Sylvestre Drive Sanitary Sewer Extension
Class Environmental Assessment

RE: Sylvestre Drive Sanitary Sewer Extension – Class EA June 2019

Responses to Sylvestre Drive Sanitary Sewer Extension
Class EA questions submitted August 19, 2019

Proposed Easement with undisclosed setback (Fig. 6 from current Sanitary EA):

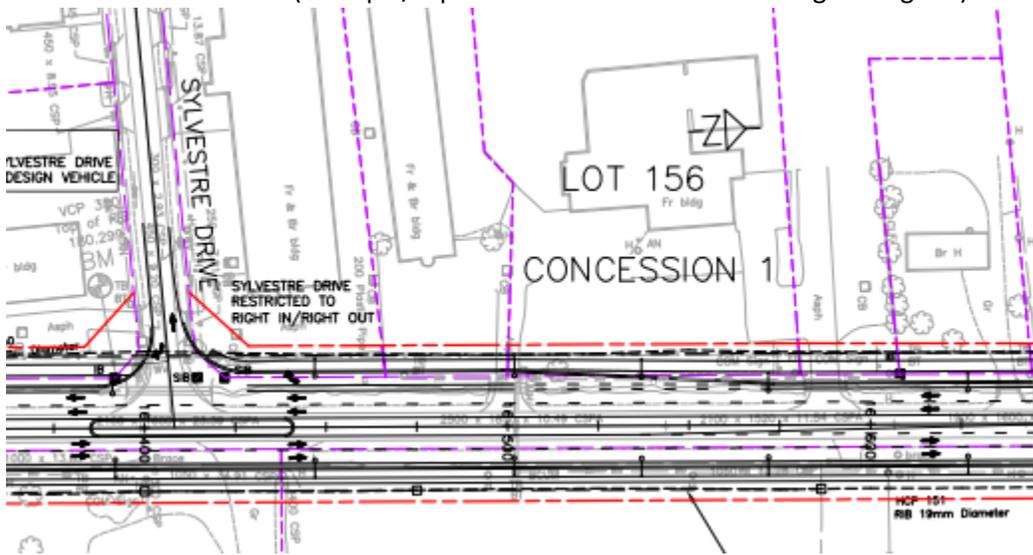
Can you please identify how this easement ties in with the other study and what the line-type is illustrating? The legend is unclear and the 3m easement appears to be setback from the existing property line. Please see the images below.

- Through review of the County Road 19 preliminary design drawings in comparison to the proposed easement within this EA, the proposed easement would be located partially within the future ROW line. The future ROW limit is 8.6 m from the existing ROW line. The extent of the easement would be approximately 0.4 m beyond this proposed ROW.
- c. It would be ideal if there wasn't an additional impact to the properties and it ends up in the County ROW which is very wide. Is the EASEMENT proposed to become part of the future right-of-way within the CR19 & CR22 EA.
 - To date this has not been discussed with the County of Essex. The Town agreed to discuss this with the County. However, this may be difficult as the County has not started the detailed design process for this phase of Manning Road.

CR19 and CR22 EA (excerpt/clips from sheets 17 & 18 including the legend):

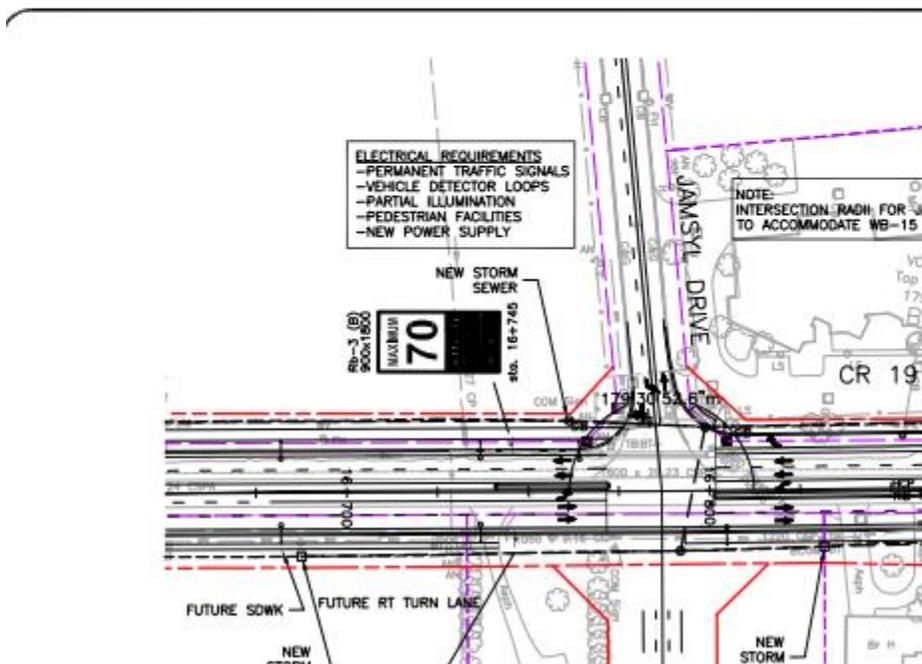
- c. It would be ideal if there wasn't an additional impact to the properties and it ends up in the County ROW which is very wide. Is the EASEMENT proposed to become part of the future right-of-way within the CR19 & CR22 EA?
